PEACH BOTTOM ATOMIC POWER STATION, UNIT 2

AMENDMENT TO FACILITY OPERATING LICENSE

Amendment No. 5
License No. DPR-44

ATTACHMENT TO LICENSE AMENDMENT NO. 5

FIGURE 3.5.1.B

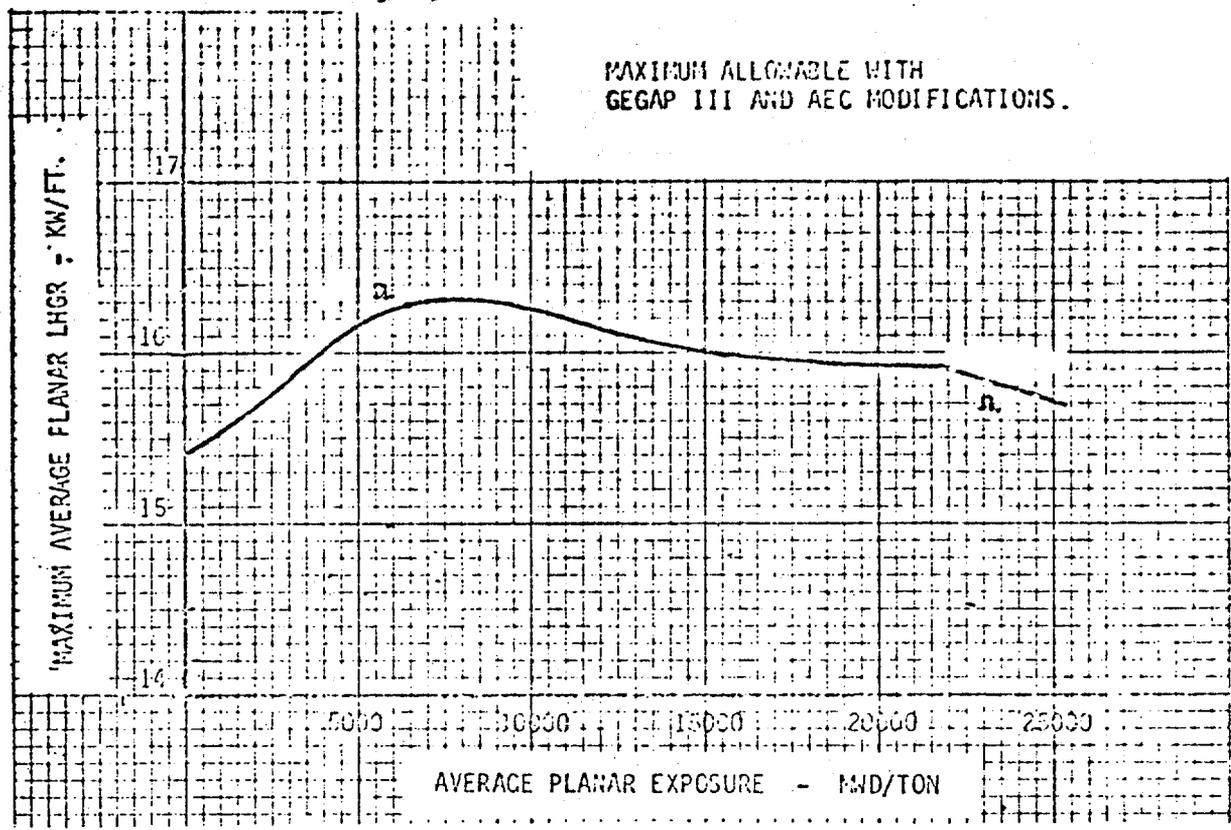
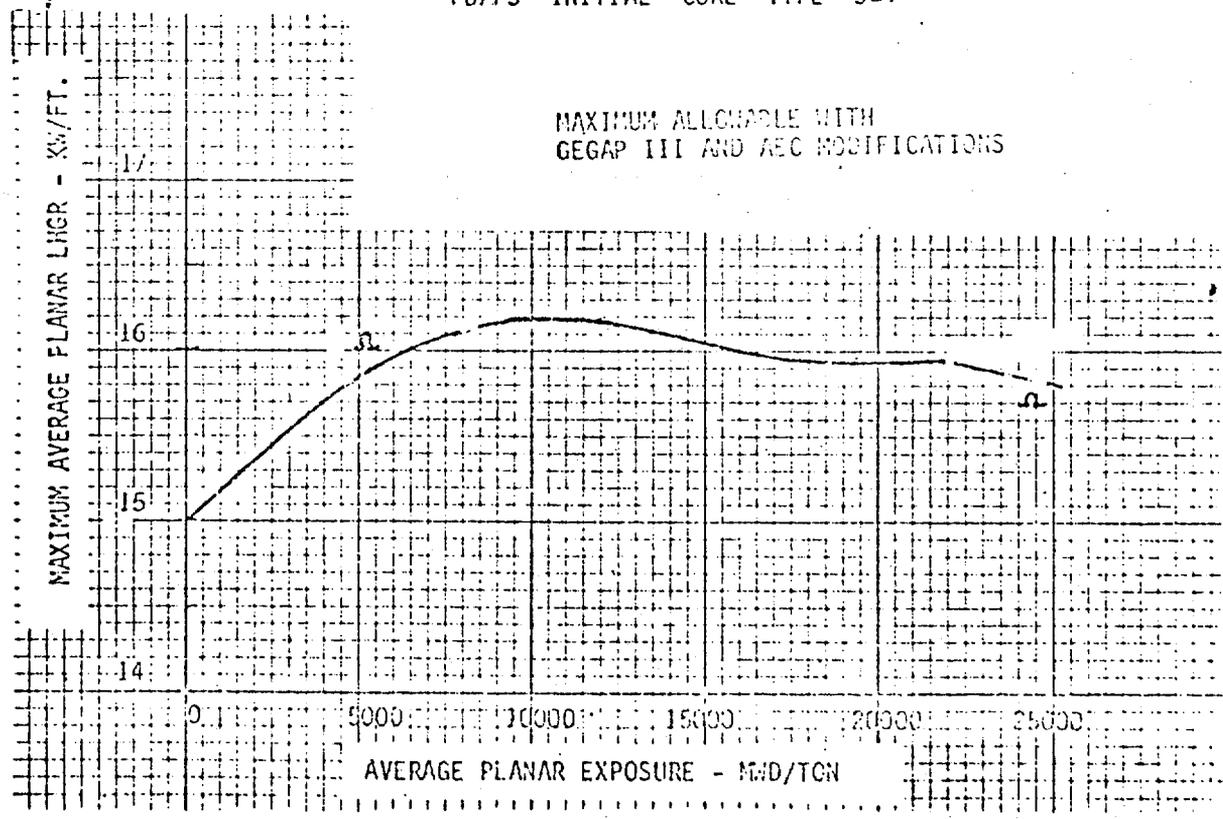
During steady state power operation, the average linear heat generation rate (LHGR) of all the rods in any fuel assembly, as a function of average planar exposure, at any axial location, shall not exceed the maximum average planar LHGR shown in Figure 3.5.1.A or Figure 3.5.1.B.*

The maximum average planar linear heat generation rates shown in Figures 3.5.1.A and 3.5.1.B are based on calculations employing the GEGAP III model described in the General Electric reports NEDO-20181, "GEGAP III, A Model for the Prediction of Pellet-Clad Thermal Conductance in BWR Fuel Rods," November 1973 with related proprietary information provided in NEDC-20181 (Proprietary), November 1973.

Philadelphia Electric Company has recalculated the fuel temperature response to the design basis loss-of-coolant accident for Peach Bottom Atomic Power Station, Units 2 and 3 using GEGAP III and has determined new MAPLHGR curves for the three fuel types presently in use. These curves (Figures 3.5.1.A and 3.5.1.B of the revised Technical Specifications) maintain the Interim Acceptance Criteria (IAC) of 2300°F peak clad temperature during a LOCA while allowing steady state power operation at higher average planar linear heat generation rates.

FIGURE 3.5.1.B

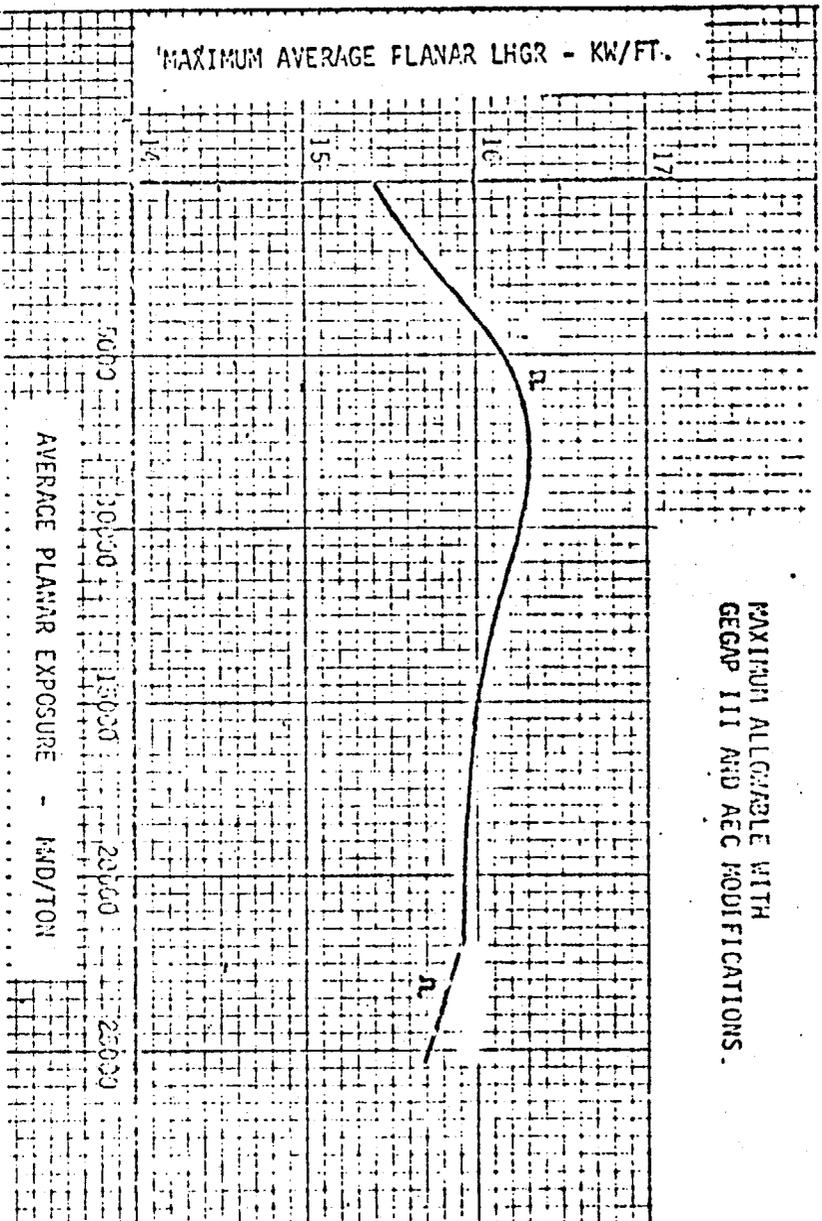
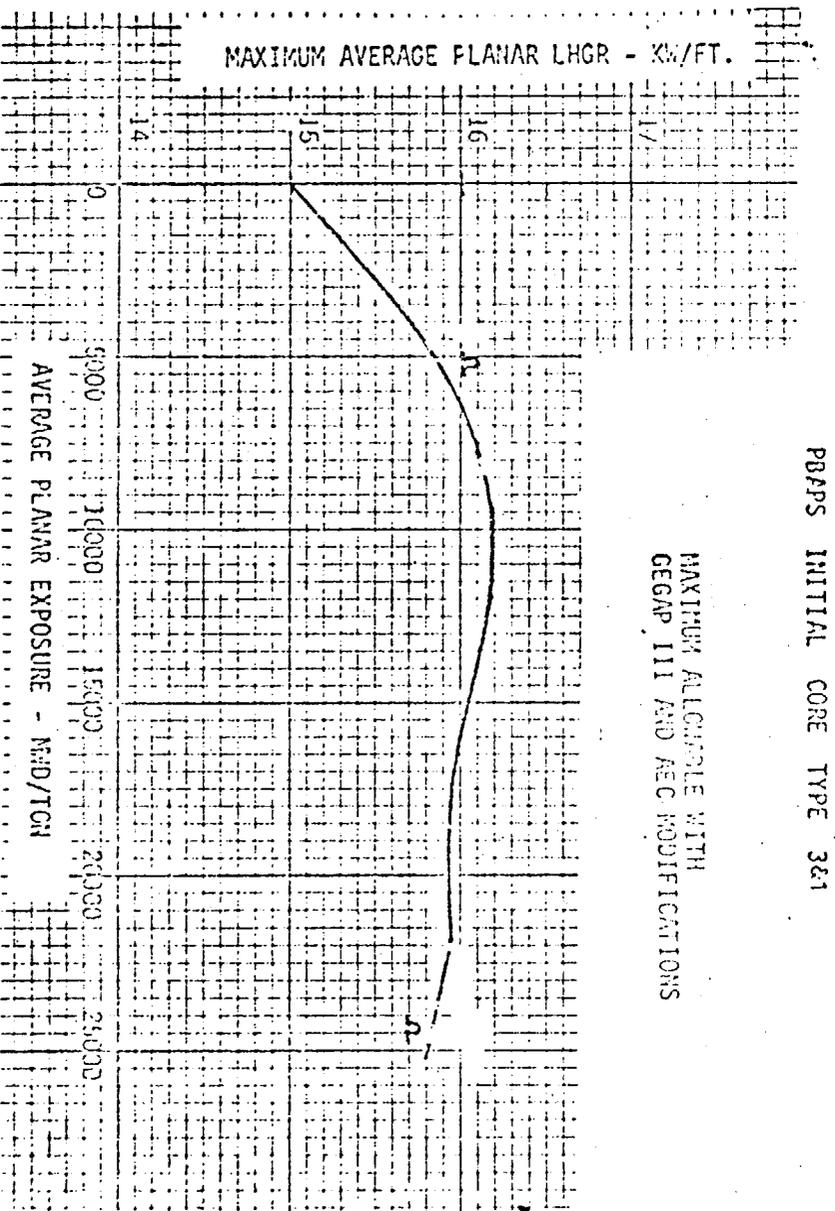
During steady state power operation, the average linear heat generation rate (LHGR) of all the rods in any fuel assembly, as a function of average planar exposure, at any axial location, shall not exceed the maximum average planar LHGR shown in Figure 3.5.1.A or Figure 3.5.1.B.*

The maximum average planar linear heat generation rates shown in Figures 3.5.1.A and 3.5.1.B are based on calculations employing the GEGAP III model described in the General Electric reports NEDO-20181, "GEGAP III, A Model for the Prediction of Pellet-Clad Thermal Conductance in BWR Fuel Rods," November 1973 with related proprietary information provided in NEDC-20181 (Proprietary), November 1973. 3
